DECISION OF THE PLANNING ADMINISTRATOR

CLASS 2 SITE PLAN REVIEW

APPLICATION NO.: 24-118643-PLN

REQUEST: A Class 2 Site Plan Review for development of a Battery Energy Storage System (BESS) and associated site improvements on an existing substation site, for properties totaling approximately 6.45 acres, zoned IG (General Industrial), and located at 1615 22nd Street SE (Marion County Assessor Map and Tax Lot: 073W35AC / 01700 and 01600).

1 SITE PLAN
C101

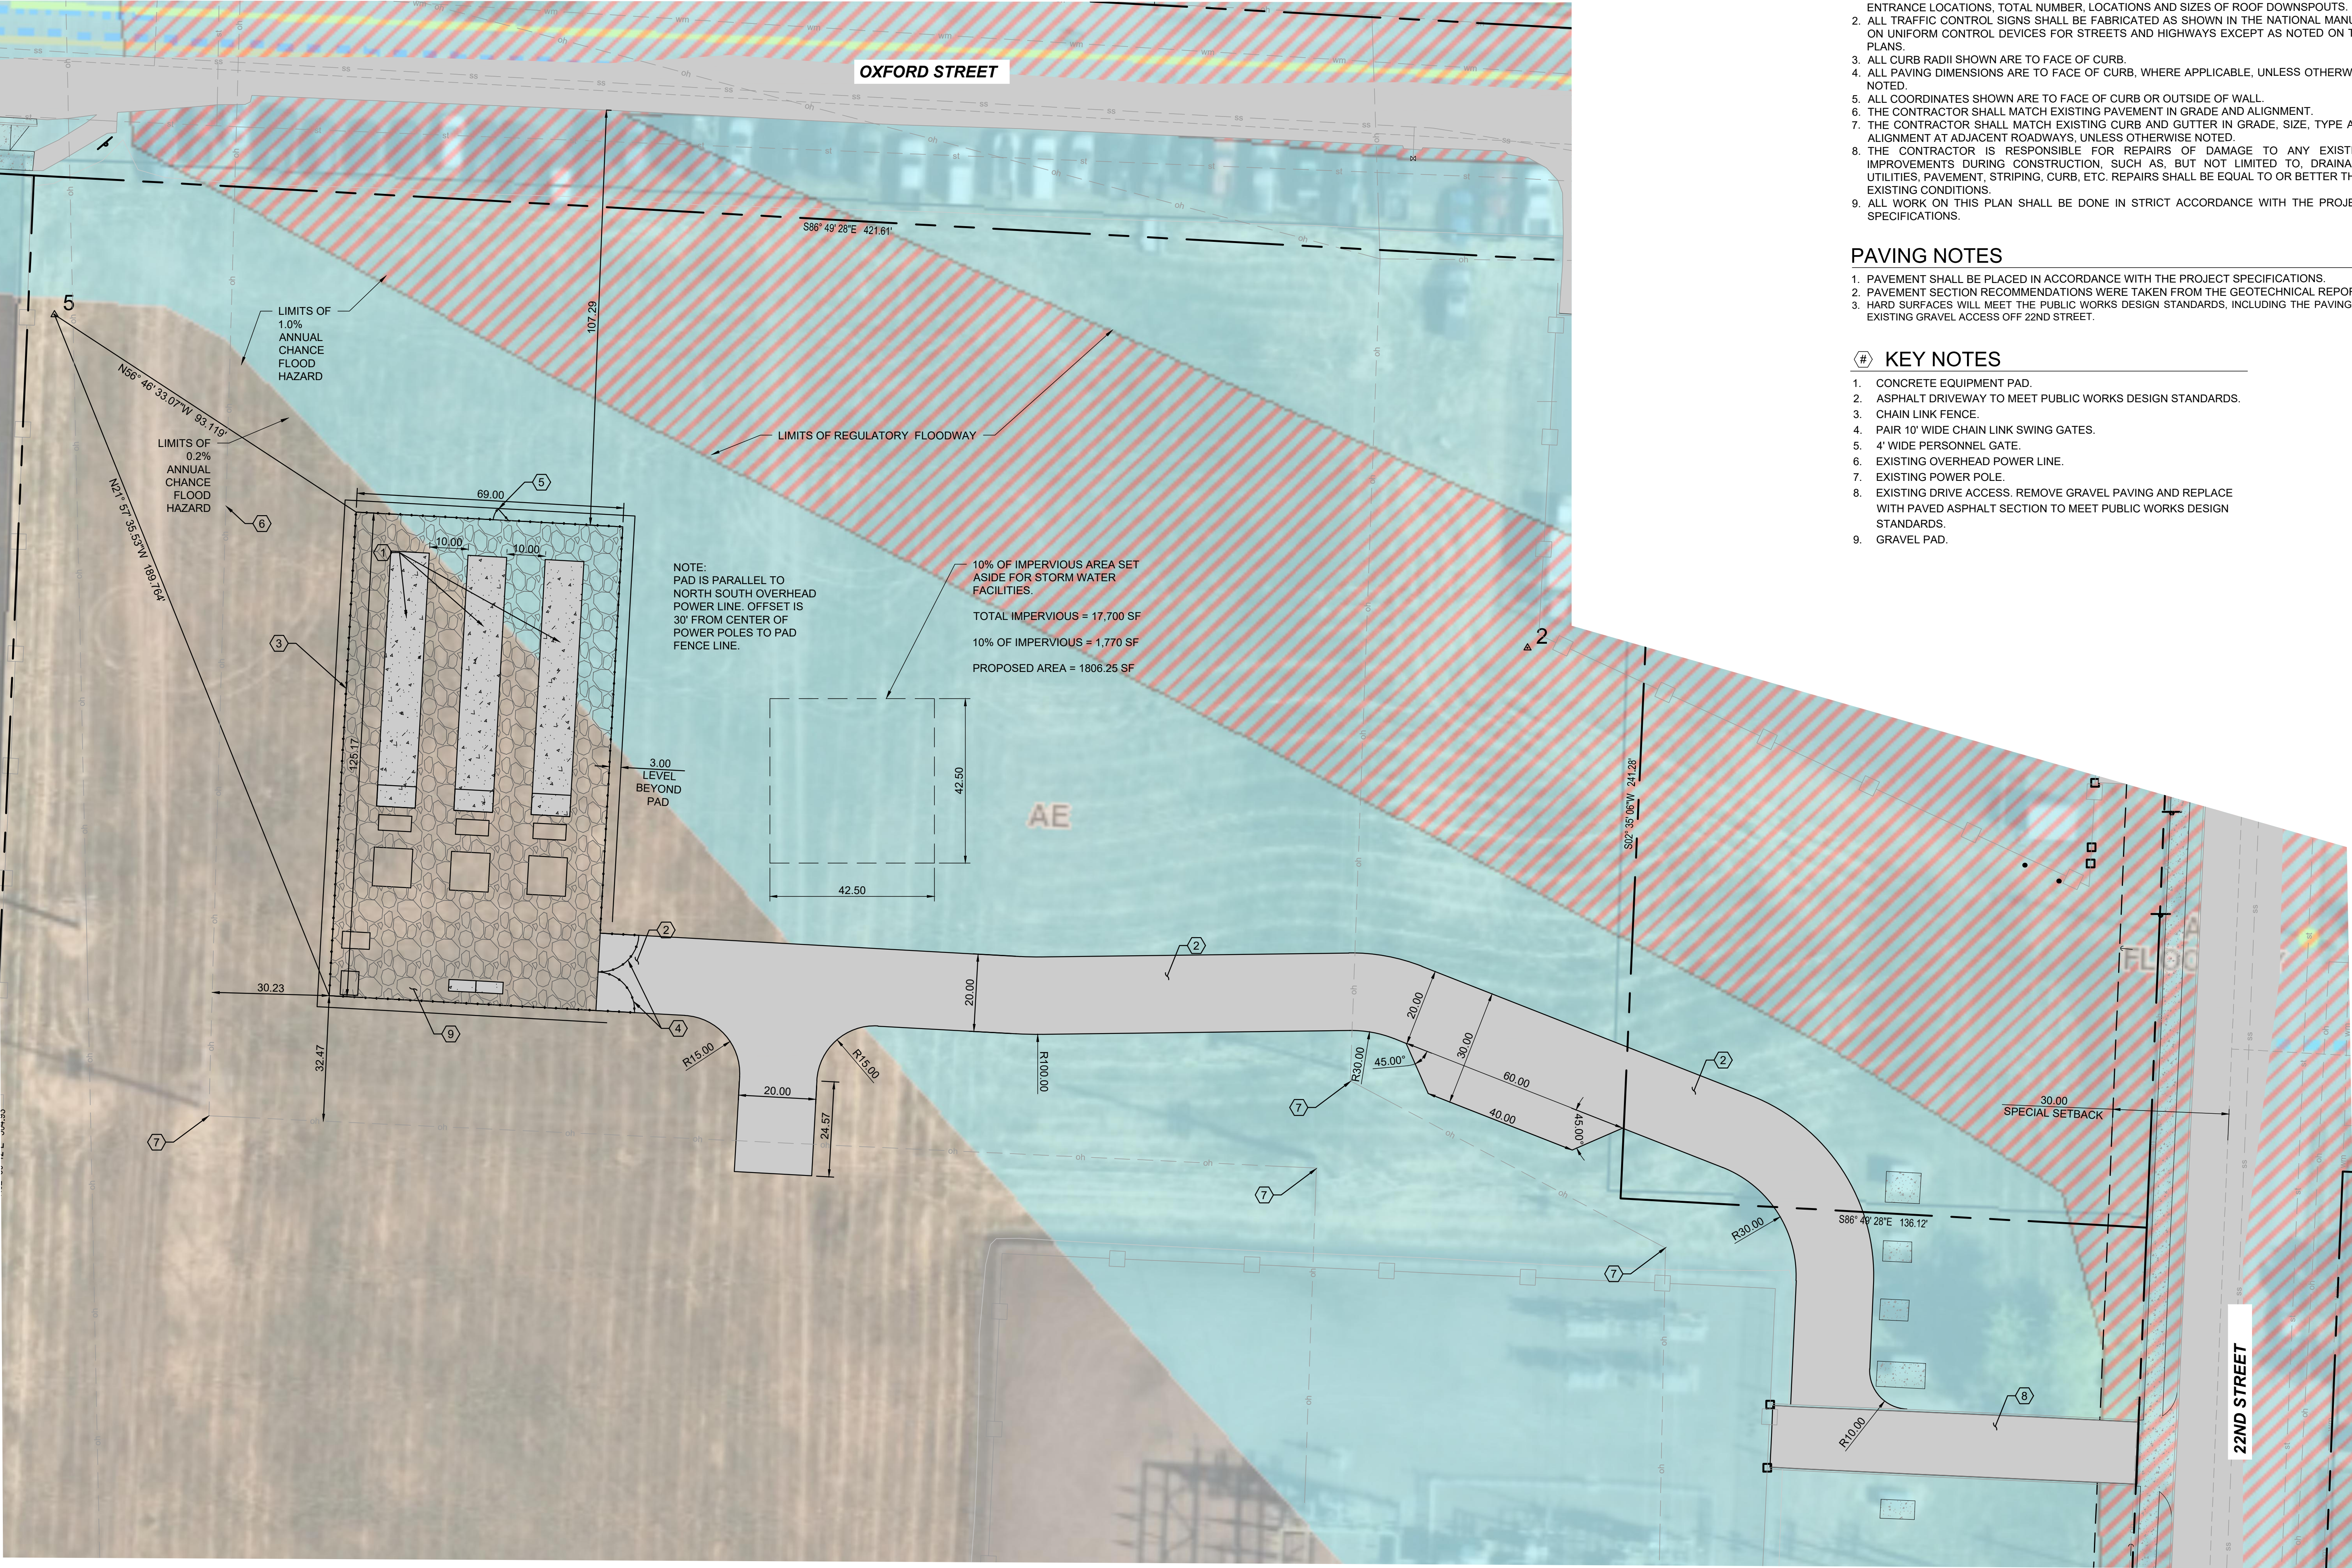
Finding: The proposal includes a vehicle use area in the form of a driveway from 22nd Street SE to the proposed BESS. The new vehicle use area crosses the property lines within the development site, however, a licensing agreement (**Attachment C**) has been obtained to ensure access.

Finding: The proposed driveway is a single driveway for ingress and egress, with a pull-off area and hammerhead turnaround provided. Therefore, this standard is met.

Finding: The proposed driveway is 20-feet wide, exceeding the minimum width of 12-feet required for one-way driveways. Therefore, this standard is met.

Finding: The proposed driveway will be composed of paved asphalt meeting the public works design standards. The existing gravel driveway providing access to 22nd Street will also be paved, as it is within the first ten feet of the property. Therefore, this standard is met.
